Access Compliance Report

Public Rights-of-Way

| Intersection ID: 10025975 | Main Street: ELM_LN | Cross Street: N/A | Location: SW |
| ADA ID: AB676BF3A445 | Ramp Type: Perp | Initial Pass/Fail: Fail | Overall Compliance: No |

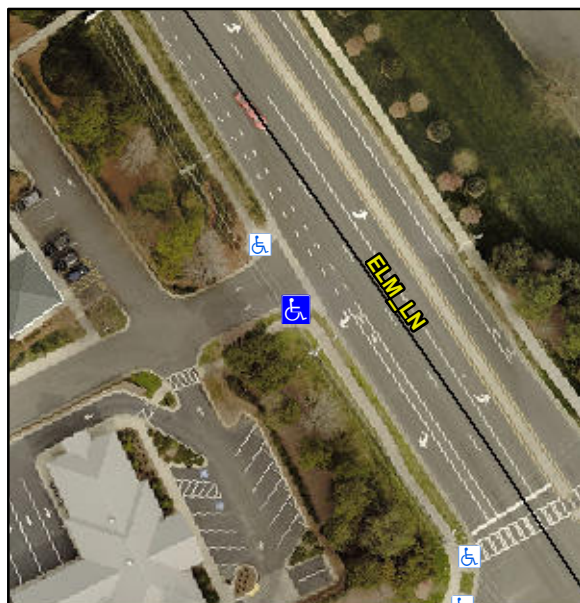
Possible Solutions:

Remove & Replace Entire Ramp.

PROW/ADA:

R304.5.1, R304.5.3

| Compliance | Description | Data | Compliance | Description | Data |
|------------|-----------------------|-------|------------|-----------------------------|------|
| No | Ramp Width (in) | 45.0 | No | Ramp XSlope (%) | 5.9 |
